32 GOLF AVENUE, MONA VALE

ISSUE FOR DEVELOPMENT APPLICATION

REV NO.	DESCRIPTION	REV DATE
A	ISSUE FOR DA APPROVAL	19.01.24
B	UPDATED FOR DA APPROVAL	22.06.24
C	FOR 4.55 APPROVAL	25.11.24

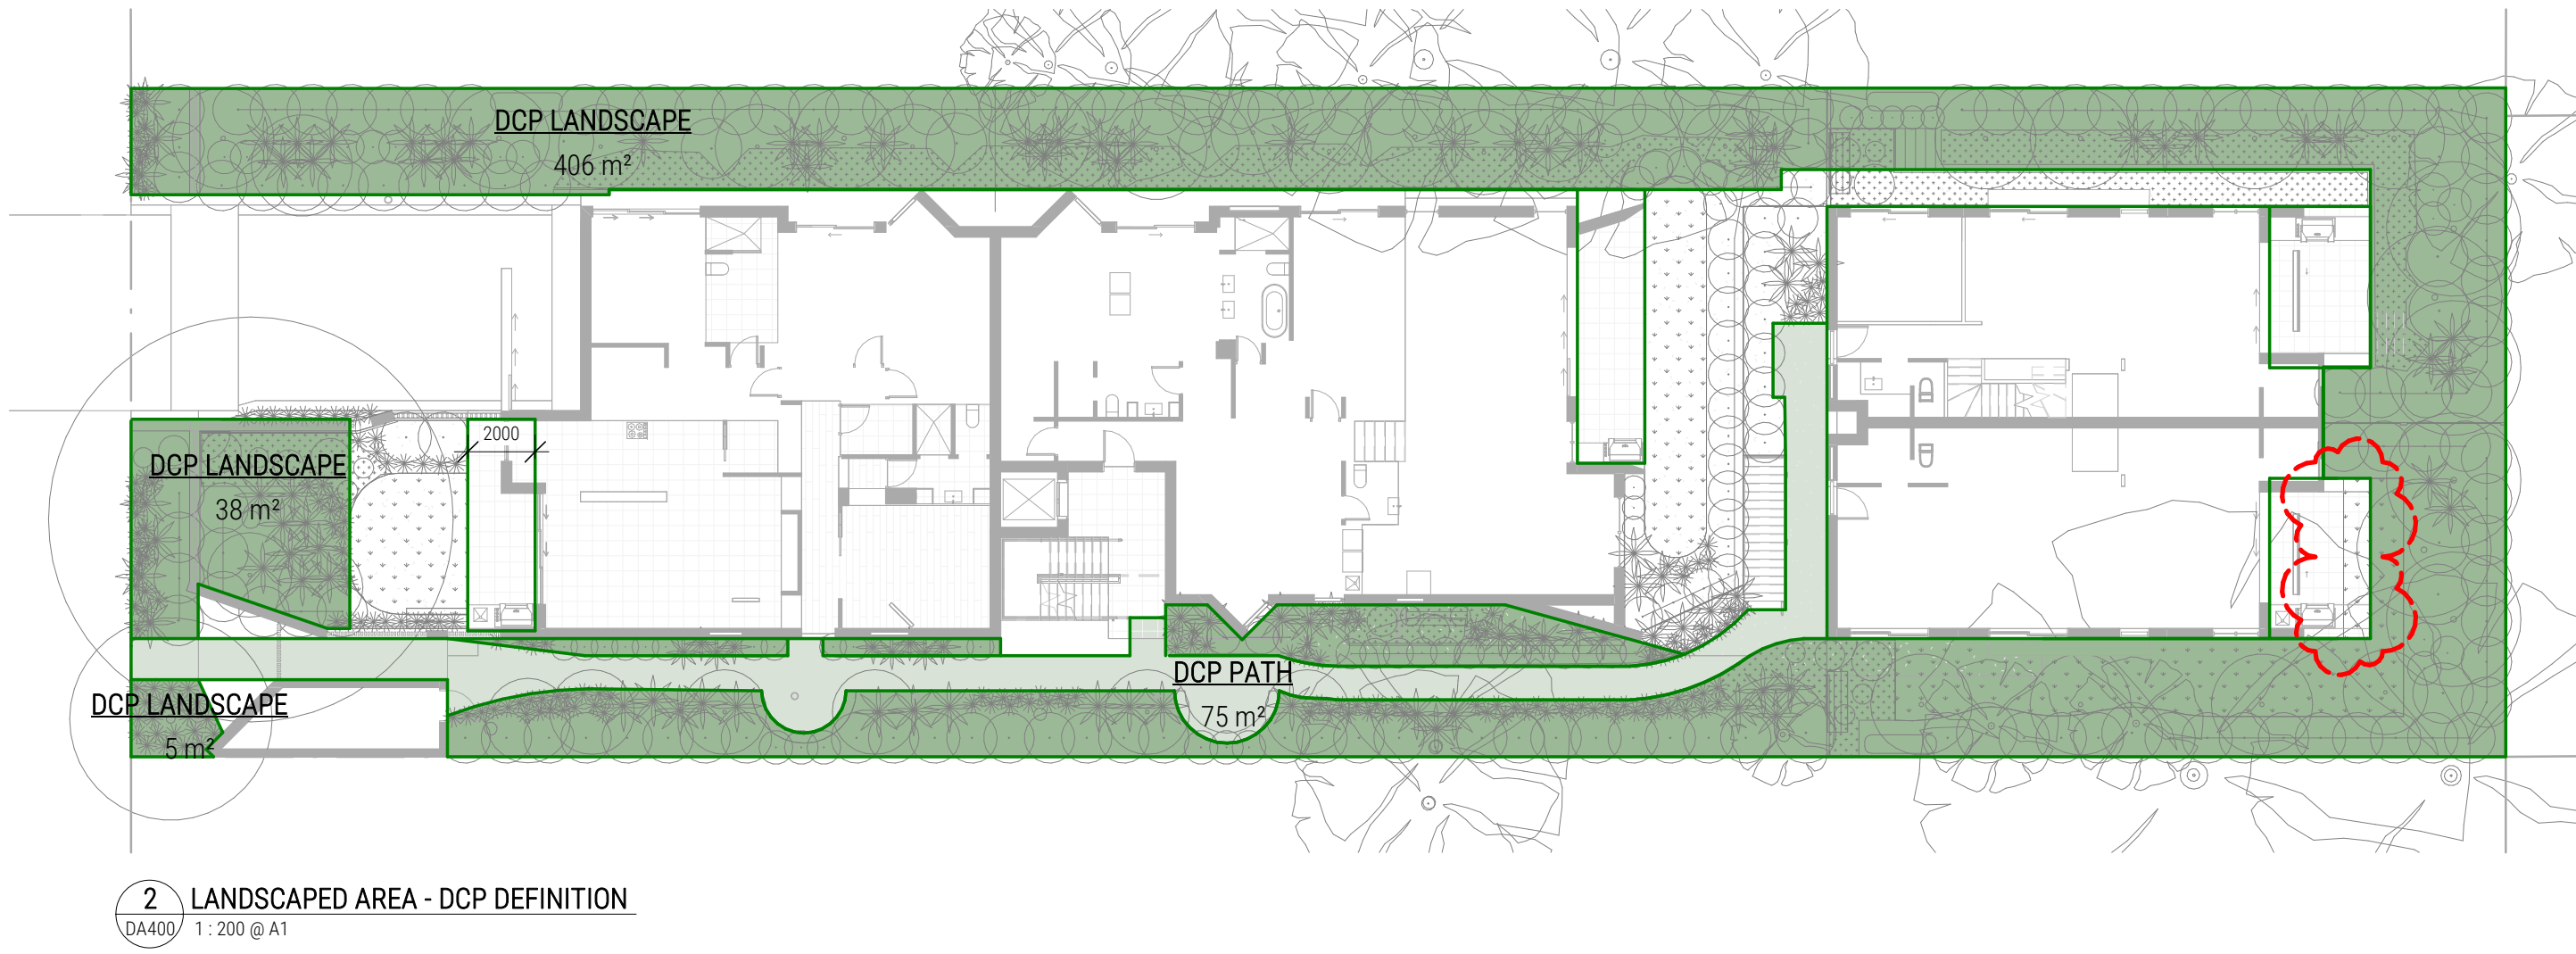
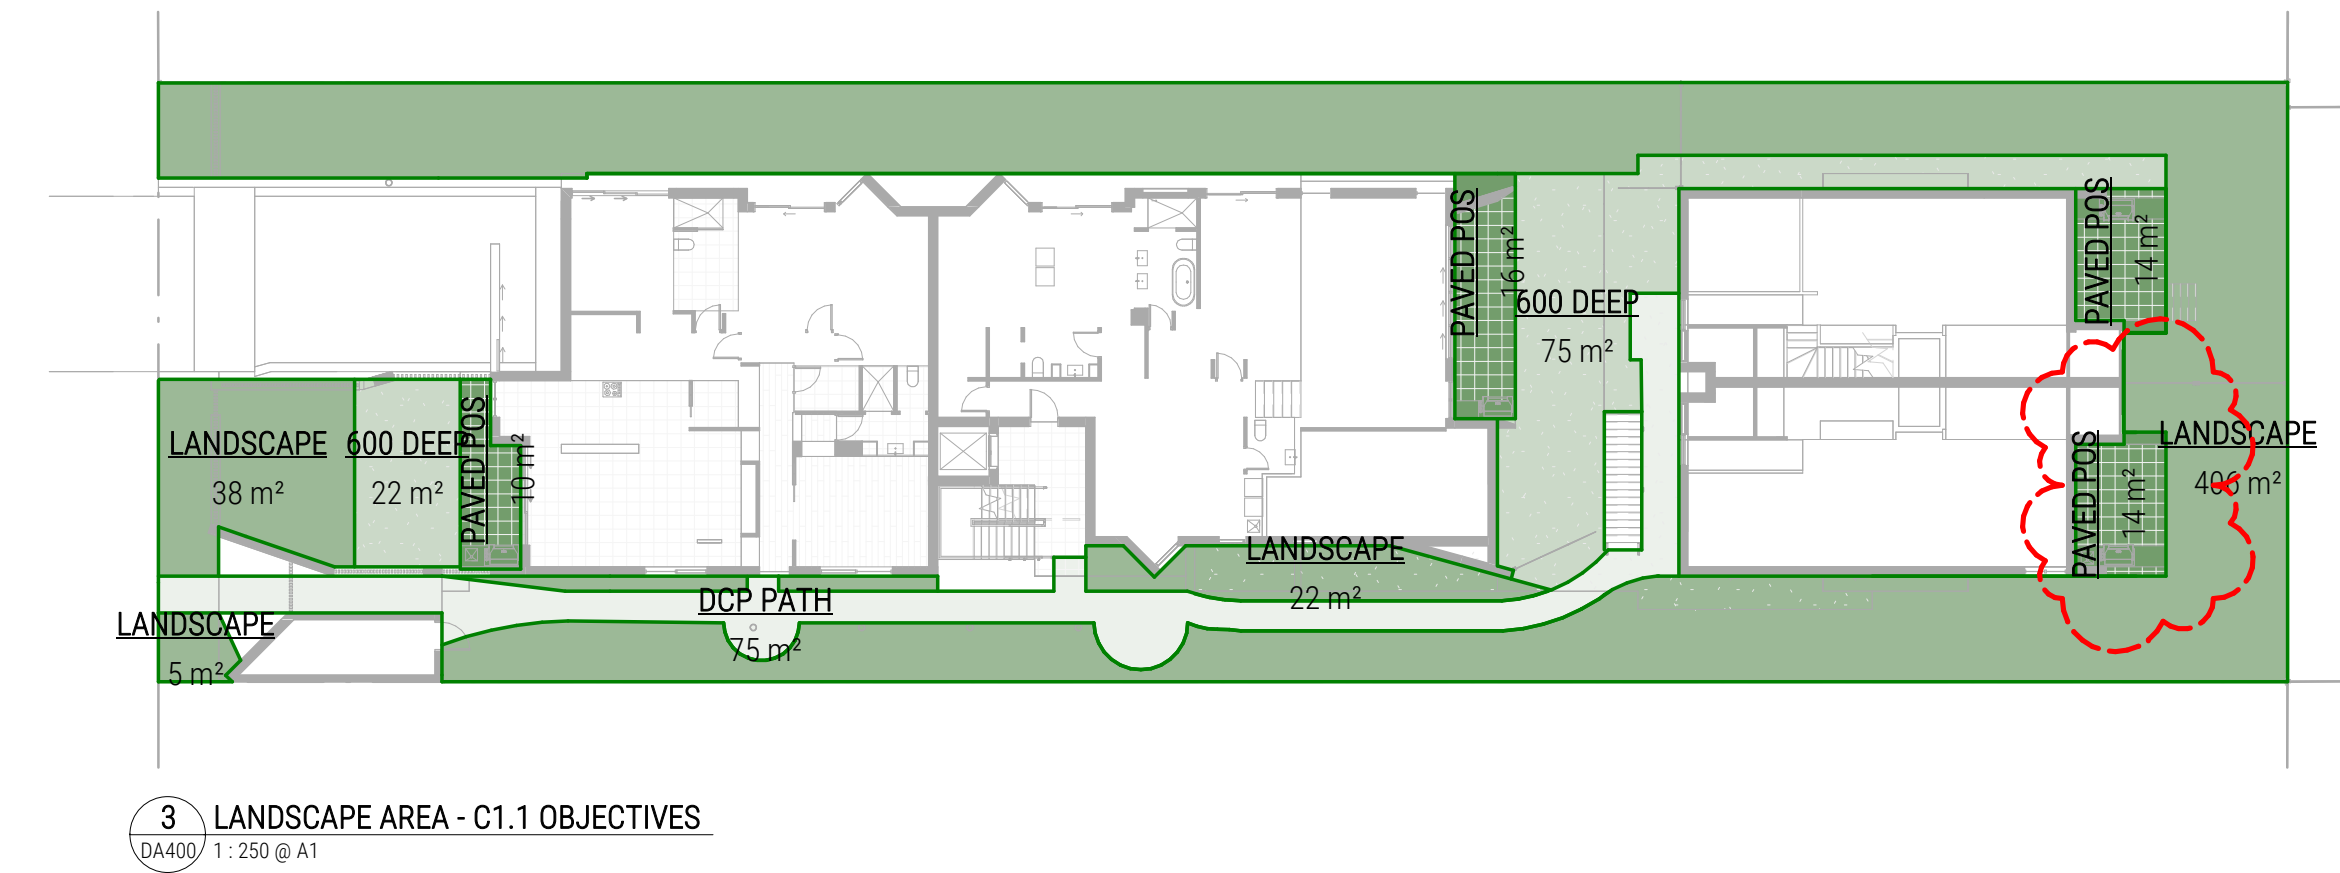
NOTE: THE LANDSCAPE AREAS IN THE MIDDLE, SIDES ARE NOW ALL 600MM INSTEAD OF 800MM AS COUNCIL ASKED TO LOWER THE HEIGHT OF THE TWO REAR UNITS. THIS HAS LOWERED THE PERCENTAGE CALCULATION BUT WE STILL KEPT 600MM AS PER C1.1 OBJECTIVES FOR SHRUBS
